City of El Paso – City Plan Commission Staff Report

Case No: SUSU12-00064 Butterfield Trail Industrial Park Unit Two
Replat A
Application Type: Resubdivision Combination
CPC Hearing Date: November 1, 2012

(F) NEW TRAIL AT PARKWAYS

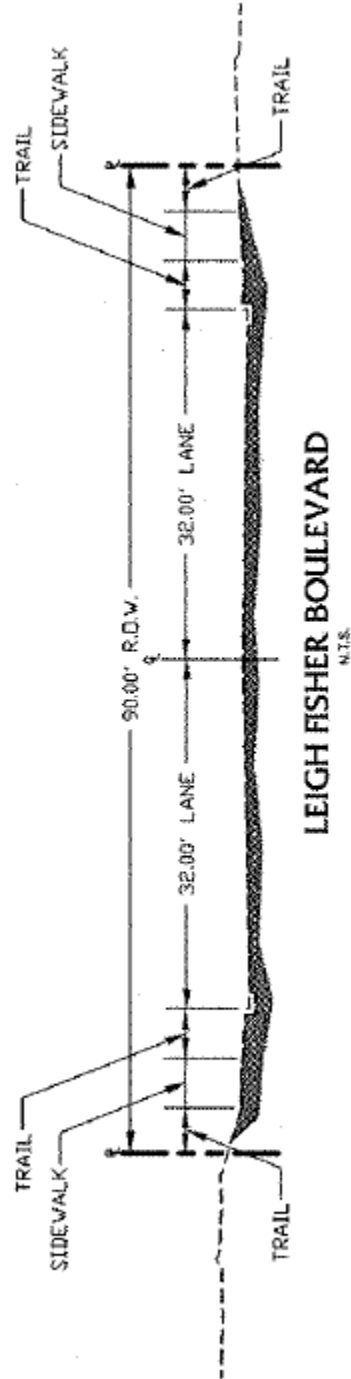
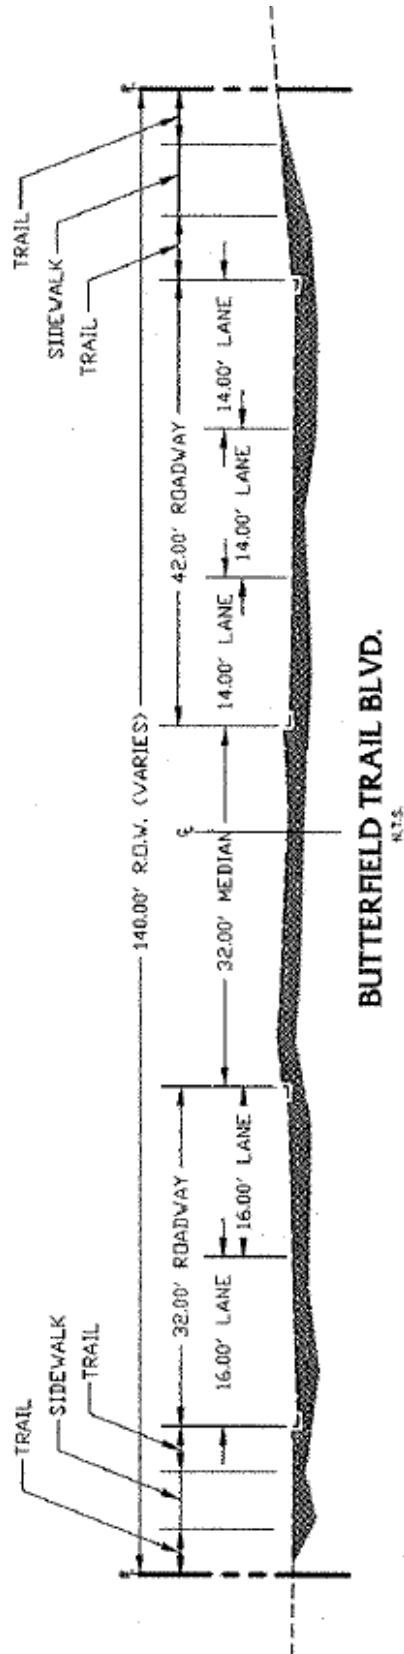
No sidewalks exist in the area and no connectivity presently exists in the industrial park at all. The compacted-screenings sidewalk is not an inferior improvement to a concrete sidewalk for various reasons. In fact the compacted-screenings sidewalk (i.e., trail) reduces impact stress upon walkers and runners alike. The section of the compacted-screenings sidewalk has an improved drainage ability that will permeate storm water rather than shed it to the street, thus partially reducing the potential storm water pollution. There is also a reduction of the Urban Heat Island Effect of the compacted-screenings versus the concrete. This would make the compacted-screenings sidewalk a more eco-rational solution as opposed to concrete. The compacted-screenings sidewalk is a better than or equal to sidewalk solution than concrete. As such we recommend the alternative design.

Please find attached a detail of the cross-section of the proposed trail detail in lieu of the required concrete walkway. The trail, as shown, fully complies with the Americans with Disabilities Act and the Texas Accessibility Standards. We respectfully request that the City Planning Commission (CPC) consider a modification of materials for this small section of the replat.

Approval with alternative subdivision improvement design. In this case, the design has been coordinated with City of El Paso Engineering staff and has been determined to meet or exceed standards within the Design Standards for Construction manual.
